MAINE TURNPIKE AUTHORITY

ADDENDUM NO. 2

CONTRACT 2023.01

**PAVEMENT REHABILITATION
AND DRAINAGE IMPROVEMENTS
MM 88.6 TO MM 98.0**

CONCRETE BARRIER & WEDGE MISCELLANEOUS DETAILS	
CONTRACT: 2023.01	SHEET NUMBER: ADD-1
1 of 1

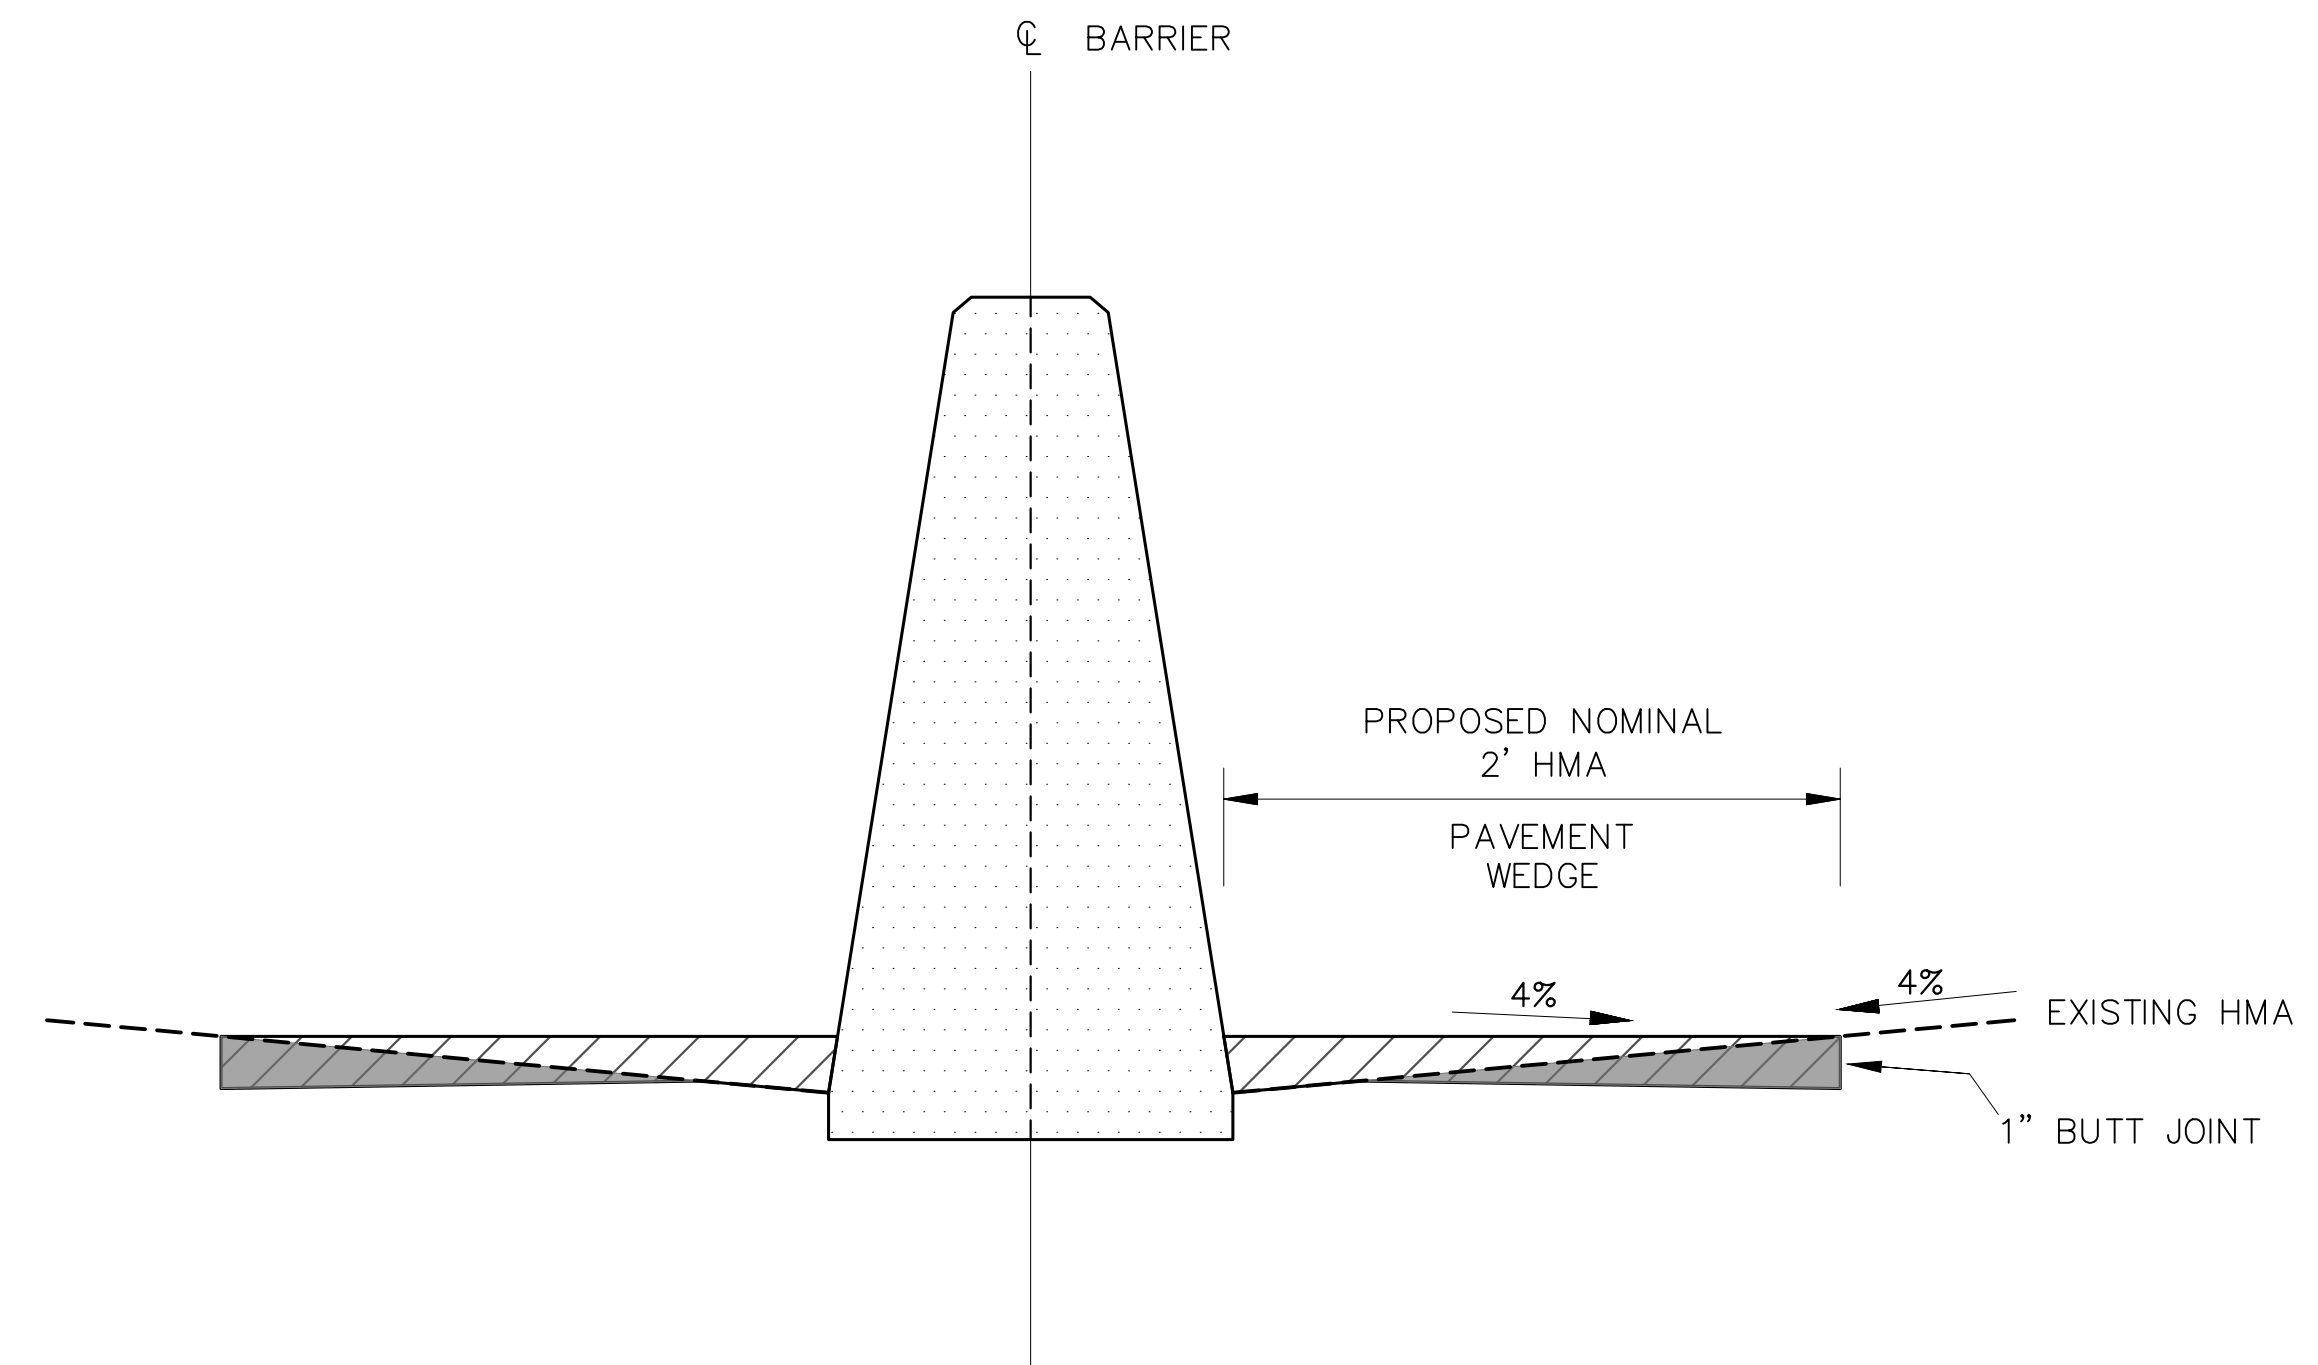
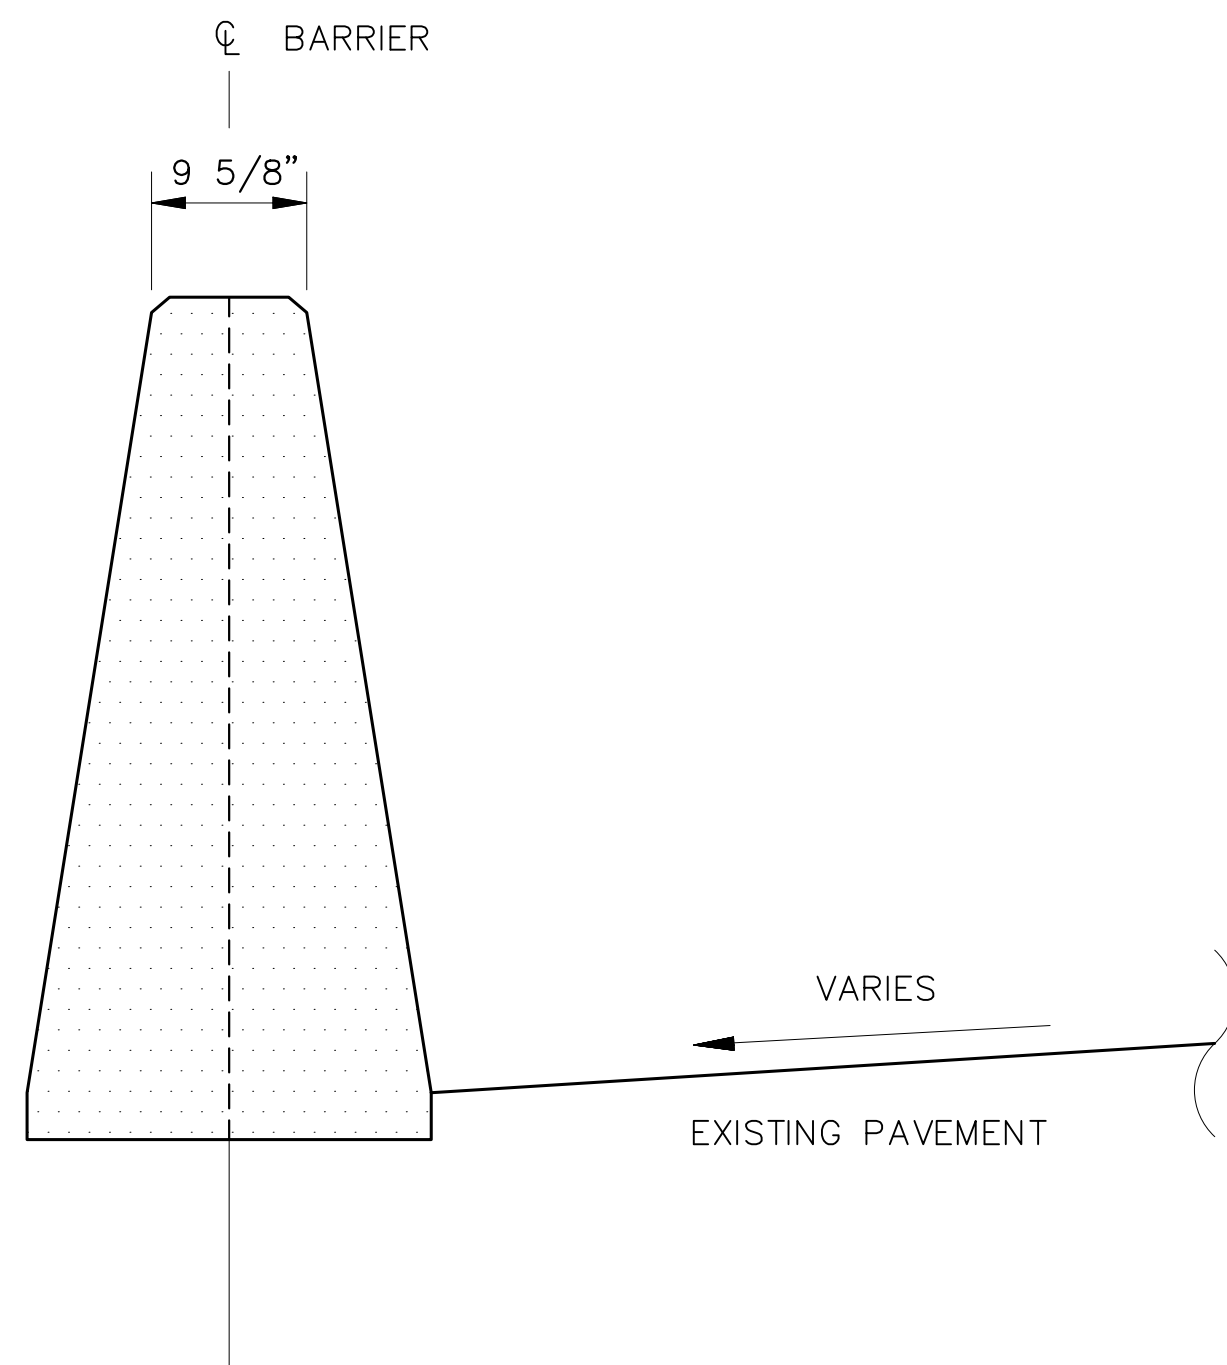
Add 103 ORT barrier plan sheet to end of plan sheets.

- a) Any pertaining to the Pre-bid Meeting.
- b) 401 HMA Gradation % Deduction Chart.
- c) Potential MM103 ORT pavement wedge, see attached draft sketch.

1. MAINE TURNPIKE AUTHORITY WILL PROVIDE MAINTENANCE OF TRAFFIC FROM 7pm TO 6am MONDAY THROUGH THURSDAY.
2. THE VERTICAL JOINTS SHALL BE HOT RUBBERED AND THIS INCIDENTAL TO THE PAVING.
3. RS-1 TACK WILL BE REQUIRED AND THIS IS INCIDENTAL TO THE PAVING.
4. THE WEDGE SHALL BE MACHINE PLACED.

SOUTH BOUND LEFT	1,295'
SOUTH BOUND RIGHT	1,145'
NORTH BOUND LEFT	1,120'
NORTH BOUND RIGHT	1,320'

TOTAL 4,880 LF
